RFP 2016-0009 - ADDENDUM 2

COLIGNY REDEVELOPMENT PROJECT

Town of Hilton Head Island, South Carolina

Date Issued: July 29, 2016

SHEET NUMBER
C2.1

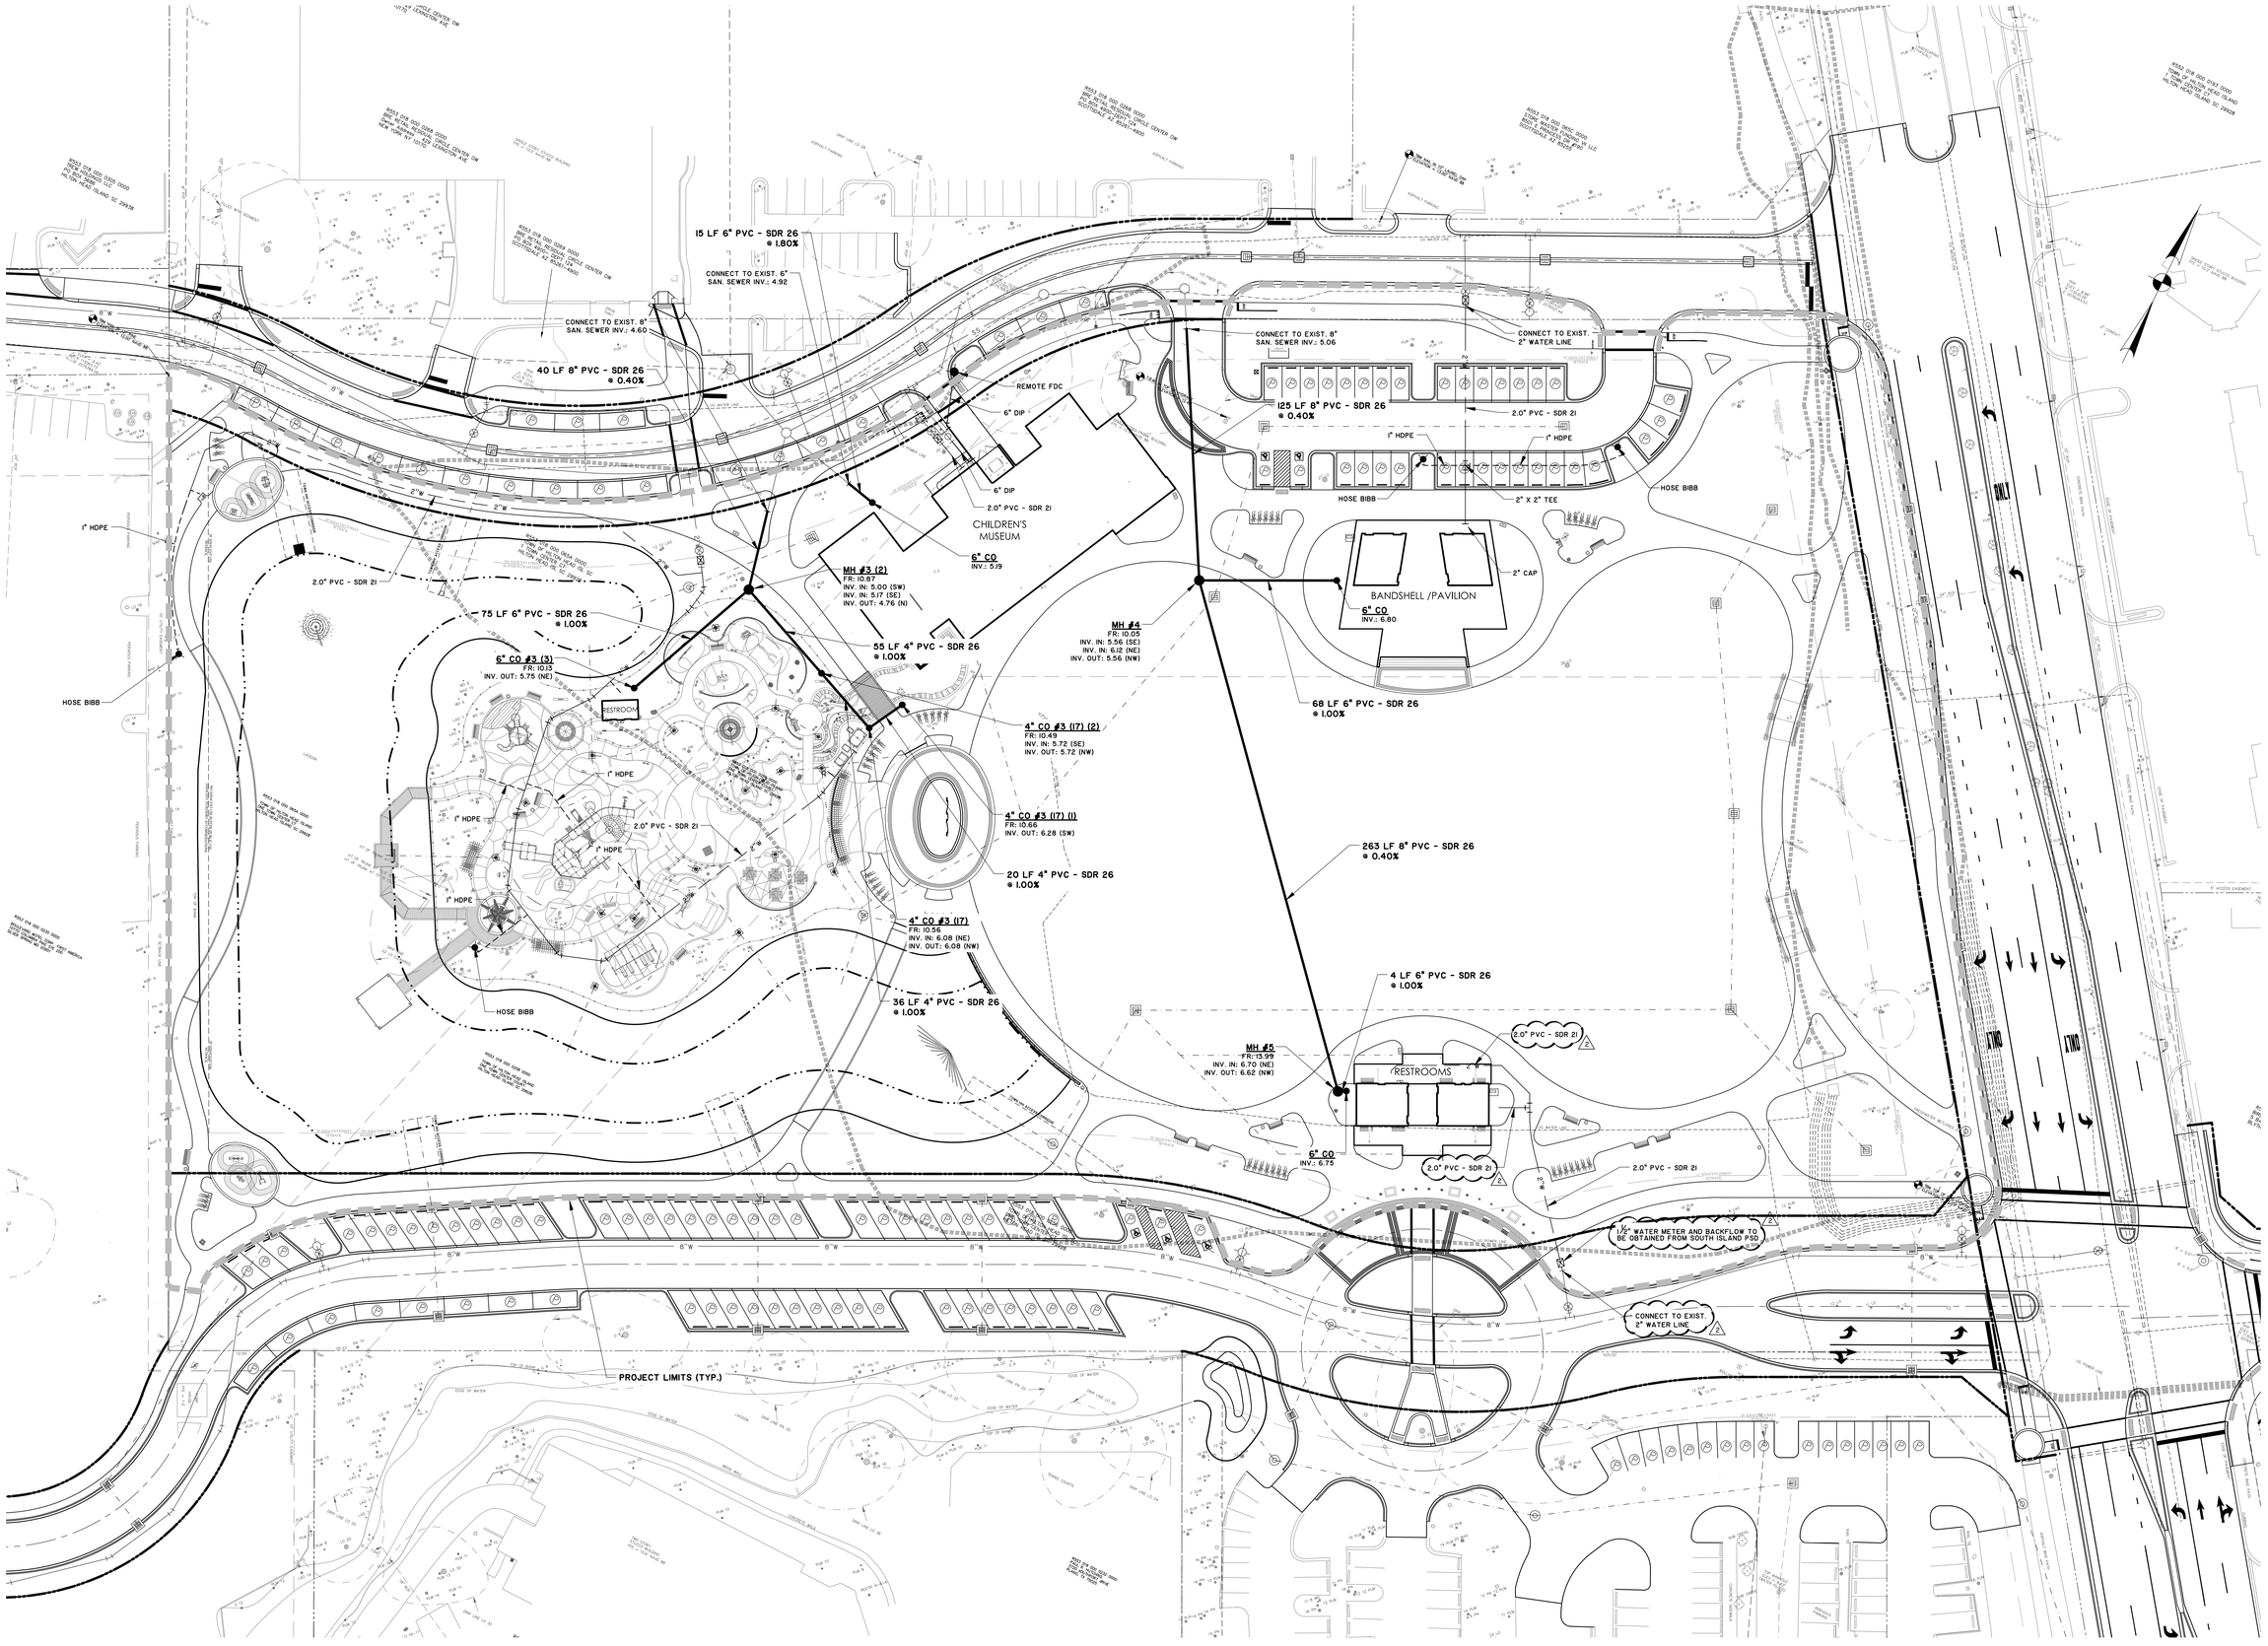
3.1 SHEET C2.1

A. Added 1 ½” meter and backflow on 2” water line serving restrooms.
B. Revised 1” water line serving restrooms to 2” water line.
C. Added connection note to exist. 2” water line.

WATER METER W/BACKFLOW PREVENTOR

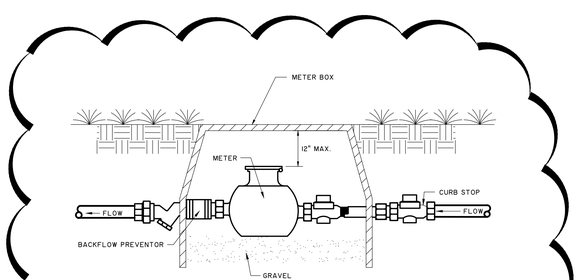
3.2 SHEET C2.2

A. Added water meter w/backflow preventor detail.

SHEET NUMBER
C3.1

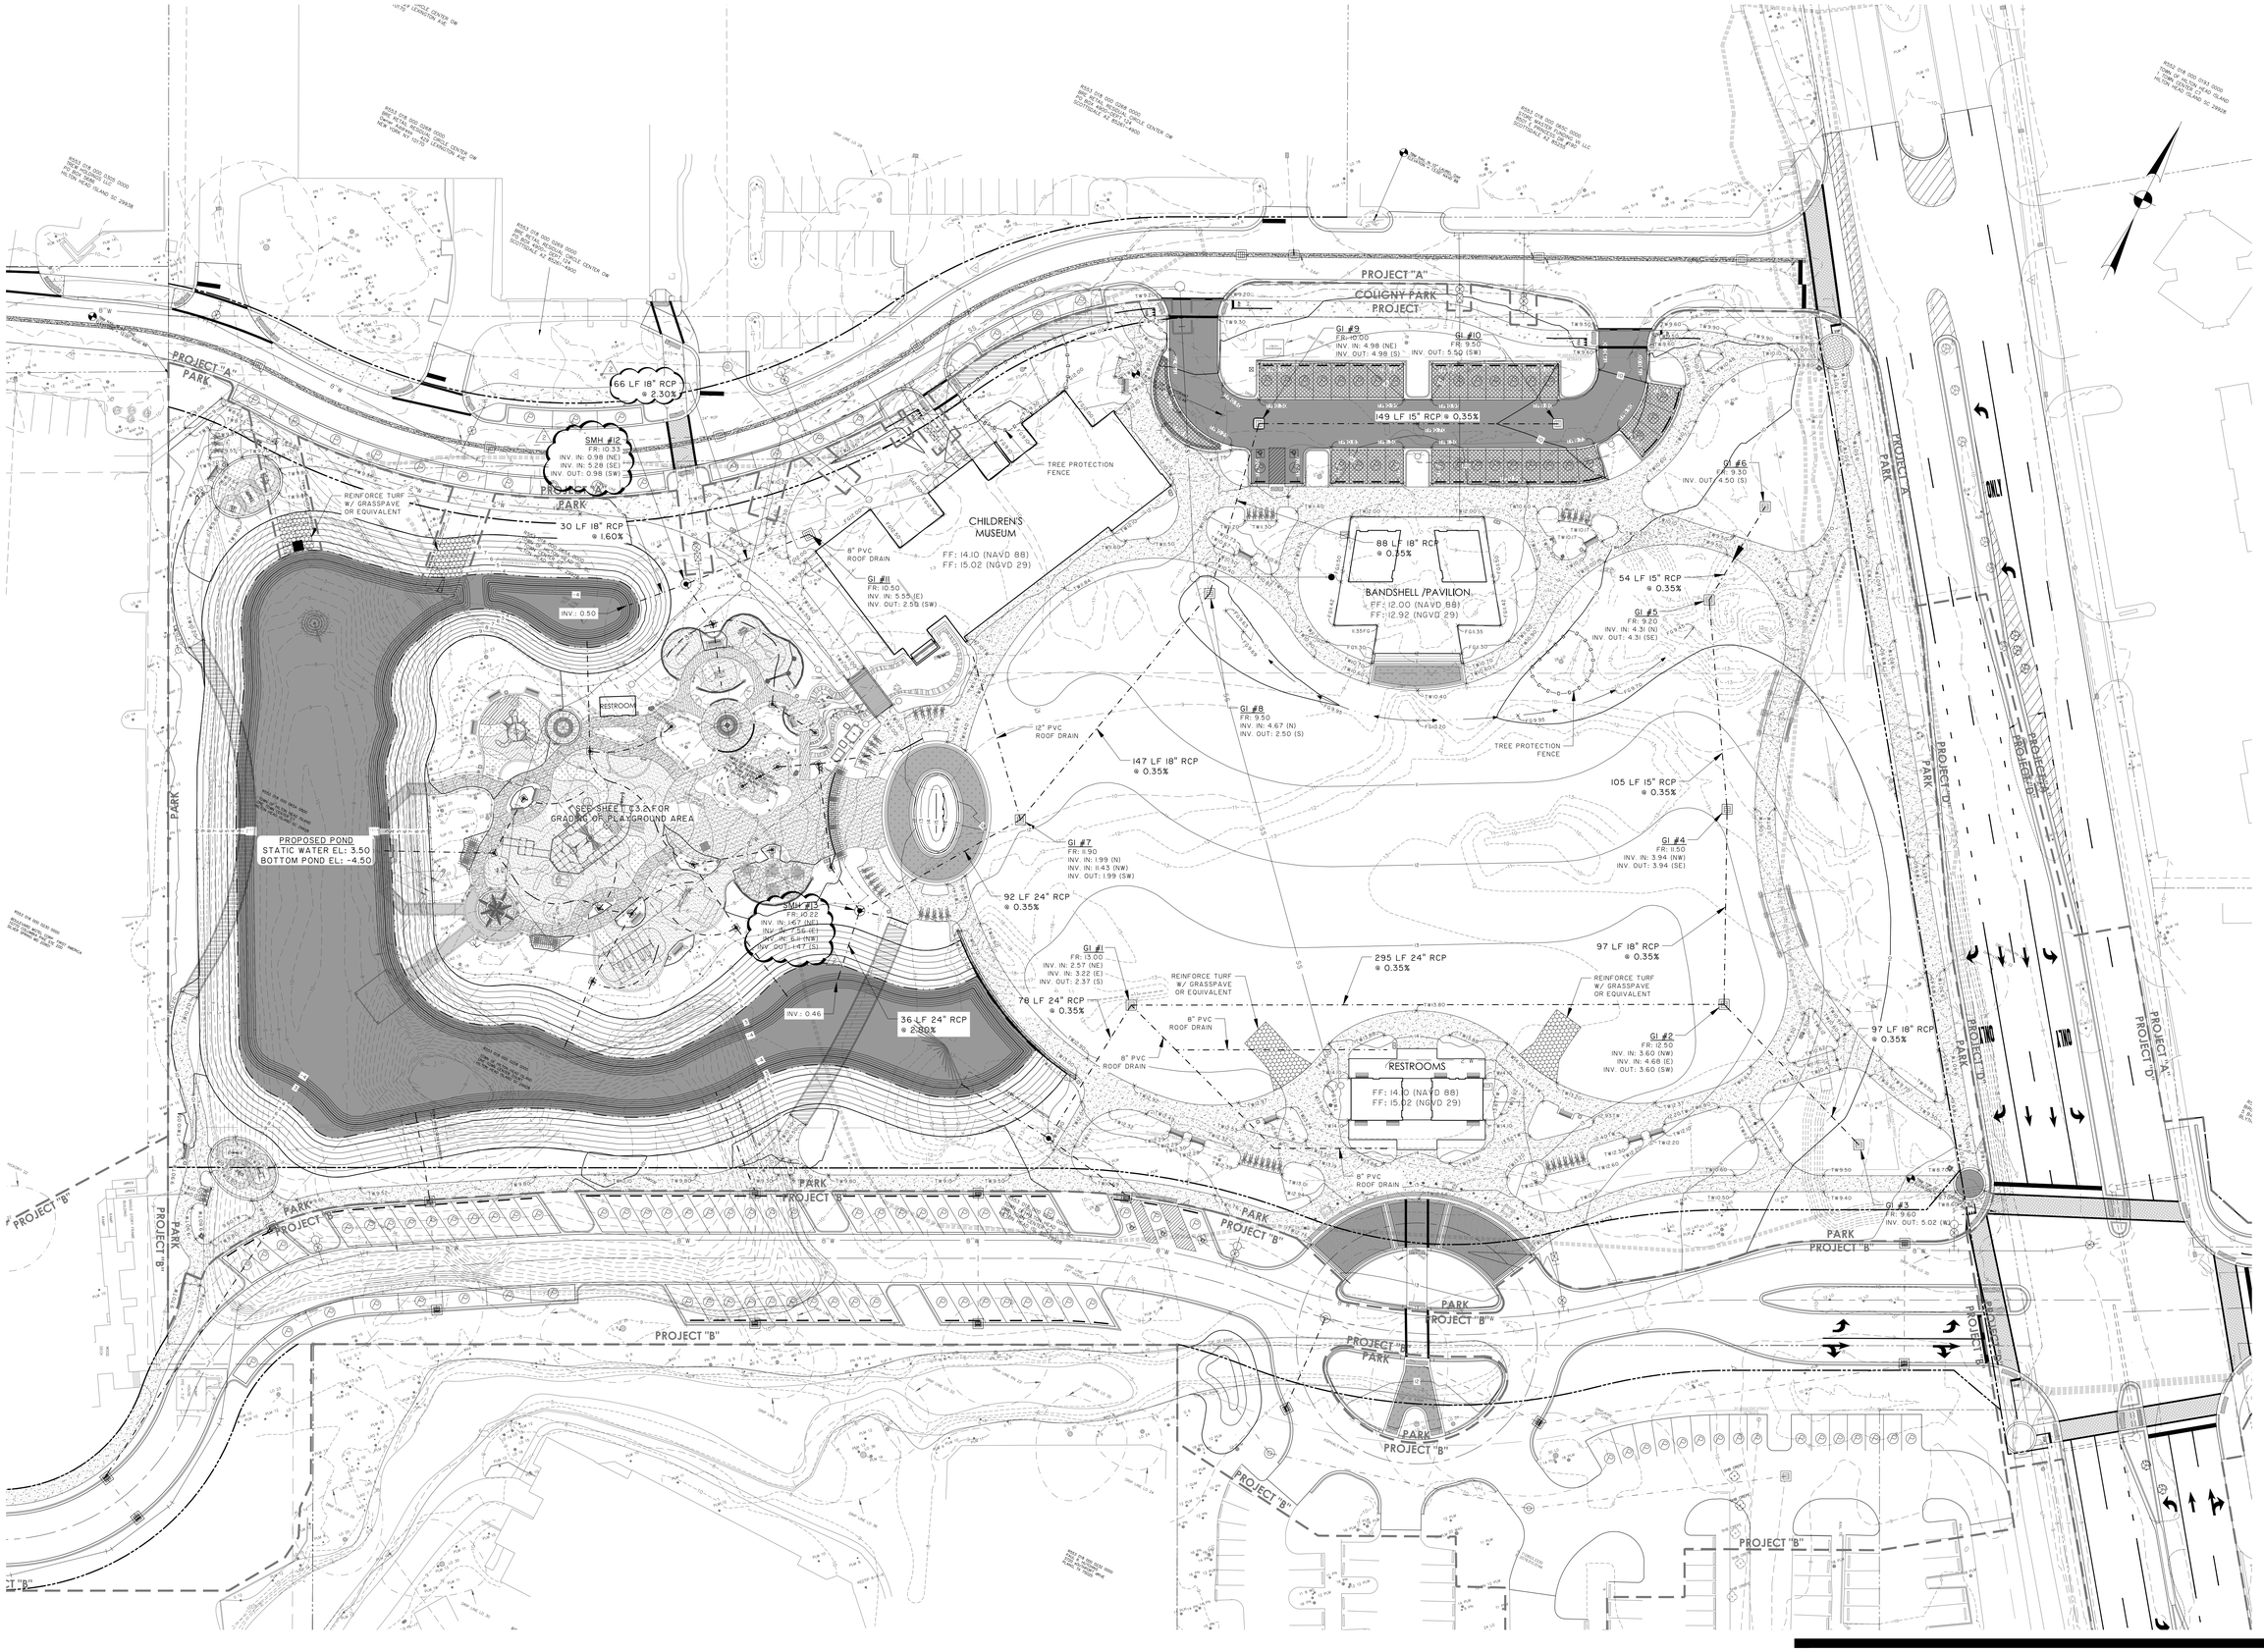
3.3 SHEET C3.1

A. Revised SMH #13 invert
B. Labeled pipe label between GI #11 & SMH #12.
C. Labeled SMH #12

SHEET NUMBER
C3.2

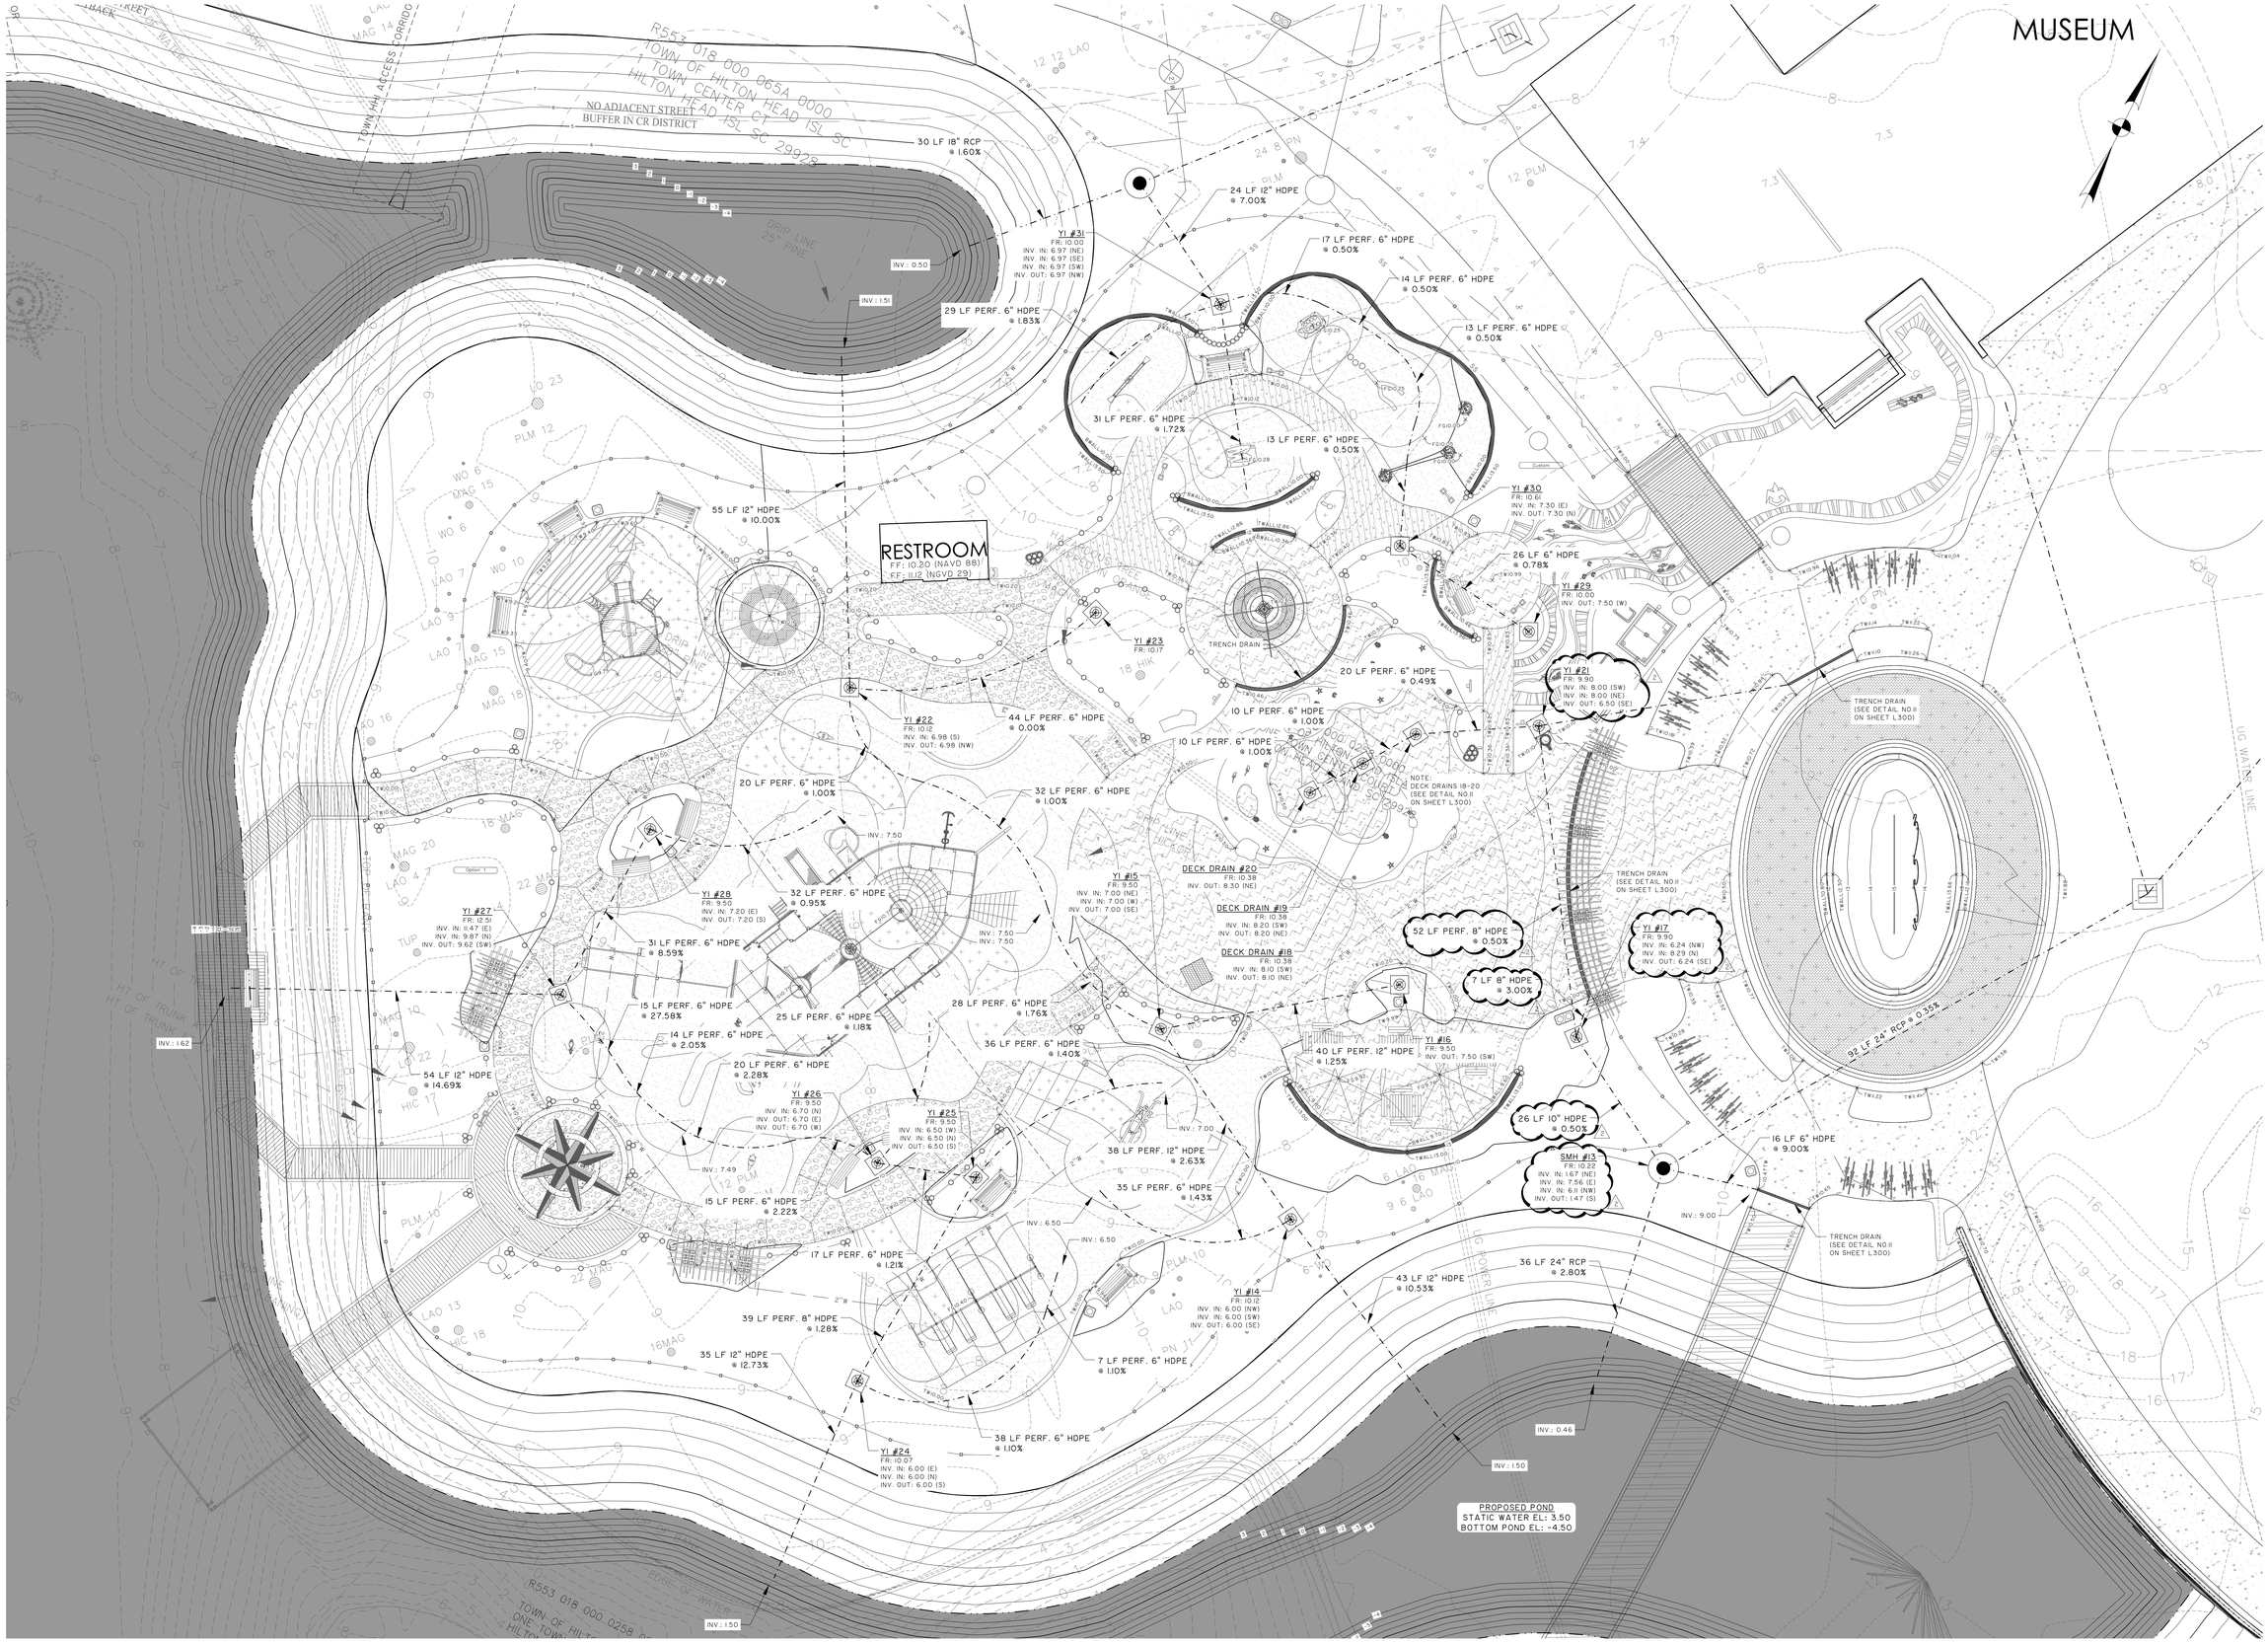
3.4 SHEET C3.2

A. Revised YI #21 invert.
B. Revised slope on 8” HDPE between YI #21 & YI #17.
C. Revised YI #17 inverts.
D. Labeled pipe label between Trench Drain & YI #17.
E. Revised slope on 10” HDPE between YI #17 & SMH #13.
F. Revised SMH #13 invert
